ROYAL COMMISSION HEARING
Nigel Priestley Presentation

M J N Priestley

COMPARISON OF HOLMES AND BECA ANALYSES

Figure A4.6.2: Pushover Analysis Results and Code Requirements Compared

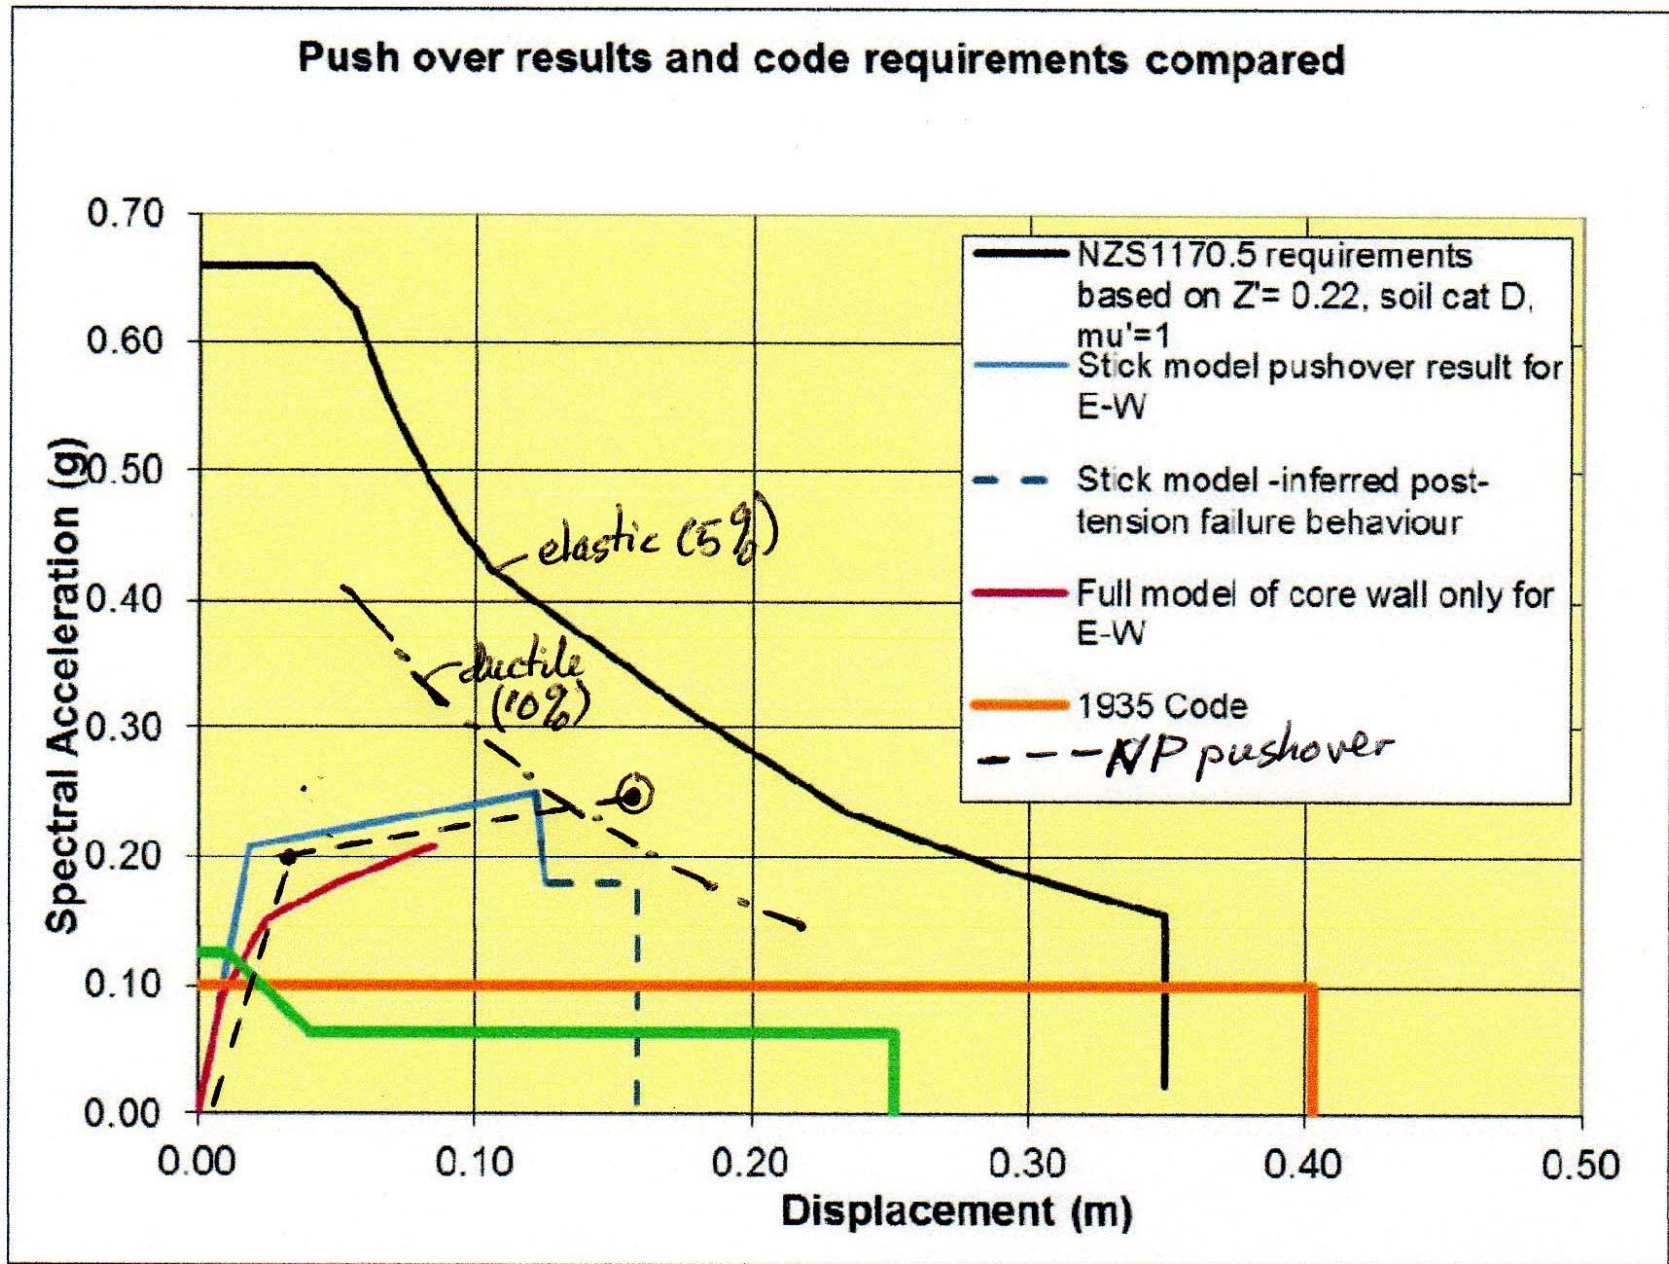
- Pushover displacement capacity should be related to ductile, not elastic spectrum. Equivalent Viscous damping estimated as 10%: reduction to demand approx 24%.
- September 4 D/C apparently related to average of horizontal spectra at 4 sites
- February 22 D/C apparently related to average of SRSS combination.
- Displacement capacity could be 30% higher than “stick” model estimate, and 80% higher than “full” model

Figure A4.7.1: Push-Over Curve and Spectral Plots for 4th September 2010 Earthquake Compared

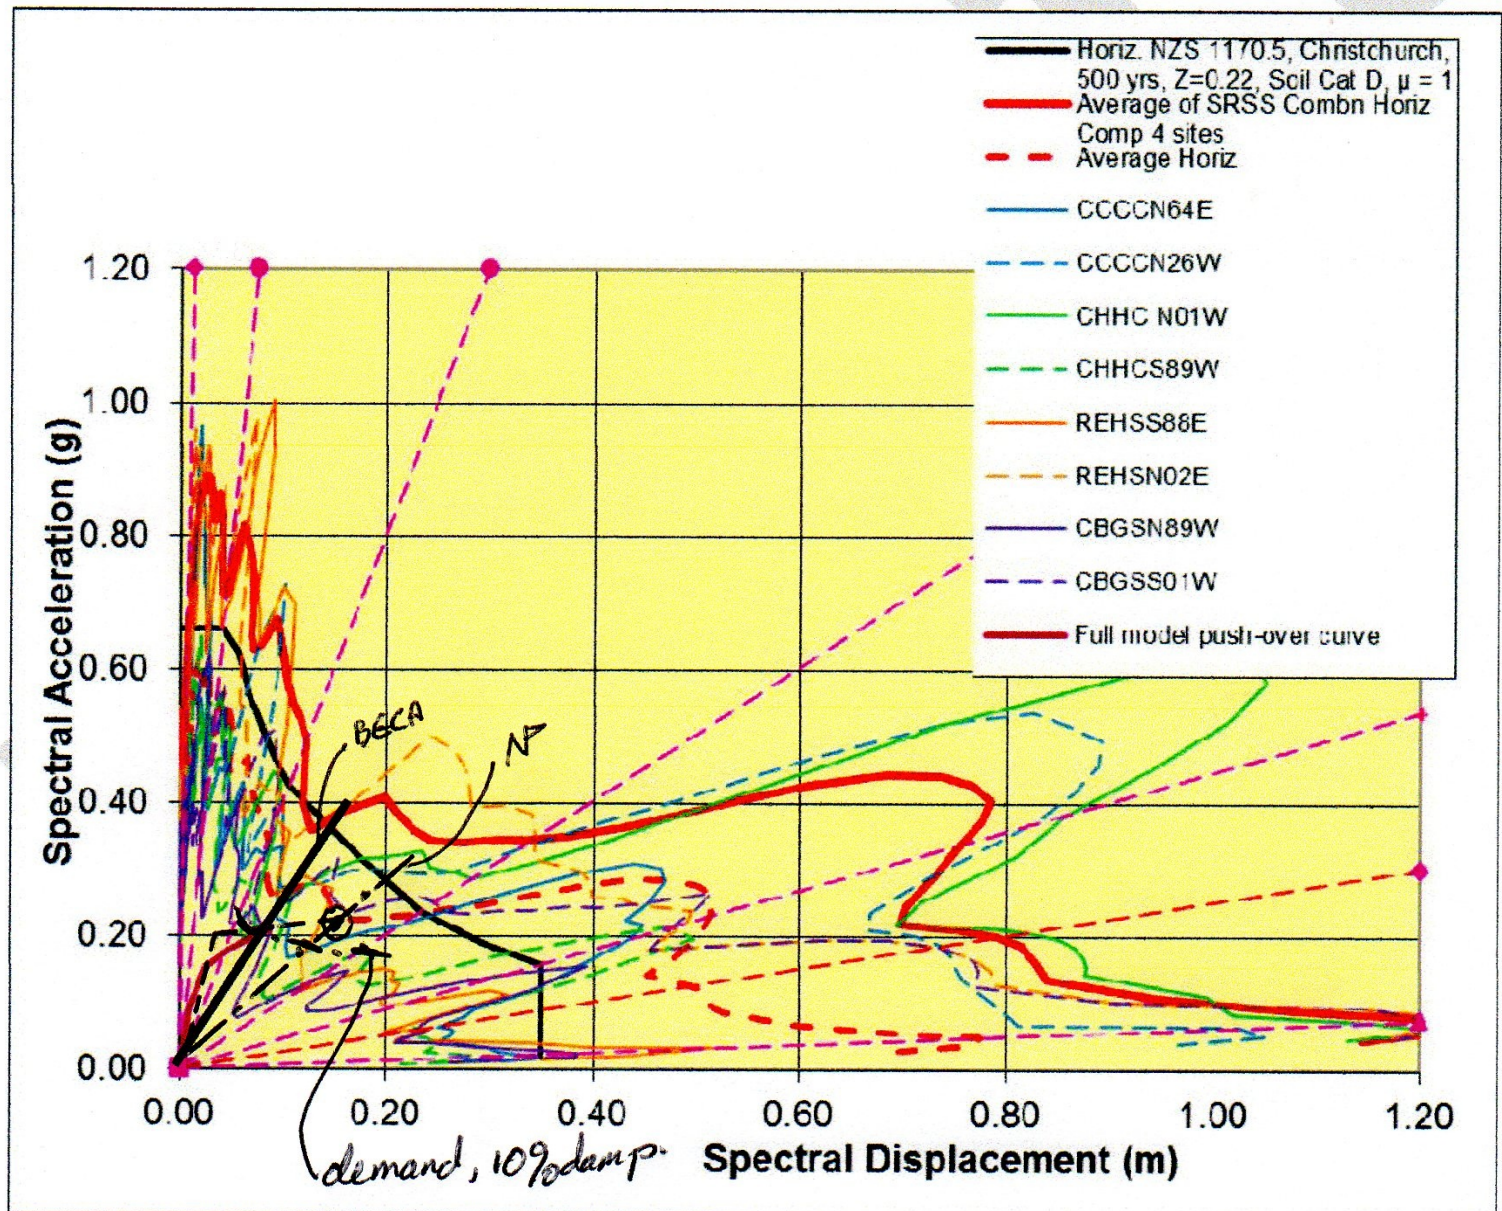
$D/C = 1.3$ (Beca, ave); = 1.9 Beca (SRSS) = 0.81 NP (Ave)

Figure A4.7.3: Push-Over Curve and Spectral Plots for 22nd February 2011 Earthquake Compared

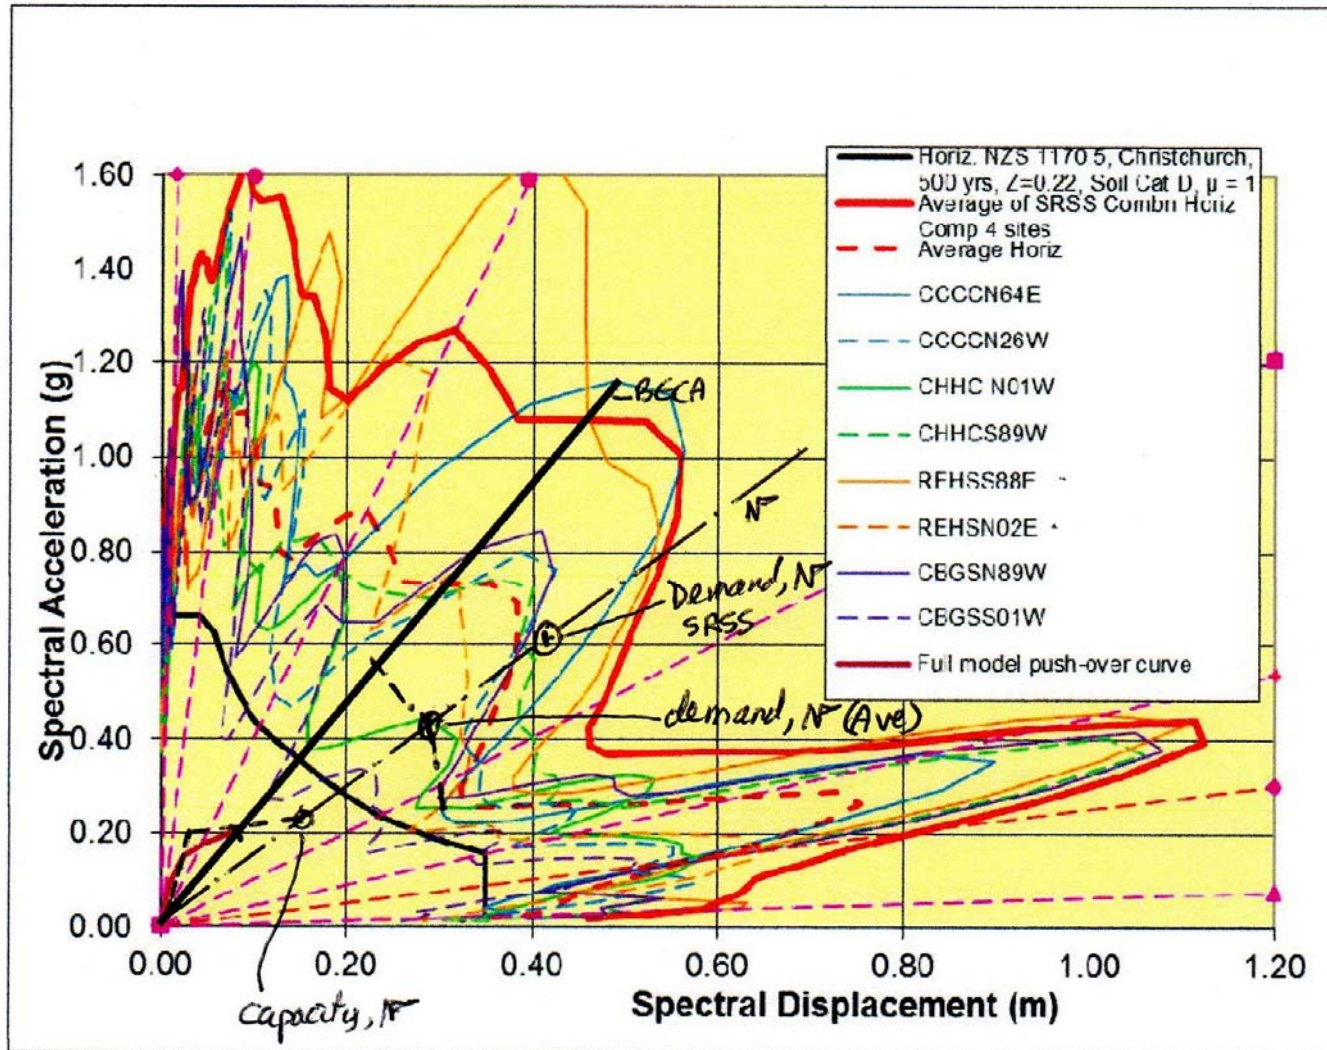
$$D/C = 3.8 \text{ (Beca, ave)} = 5.9 \text{ (Beca, SRSS)} = 2.0 \text{ (NP, ave)} \\ = 2.7 \text{ (NP, SRSS)}$$
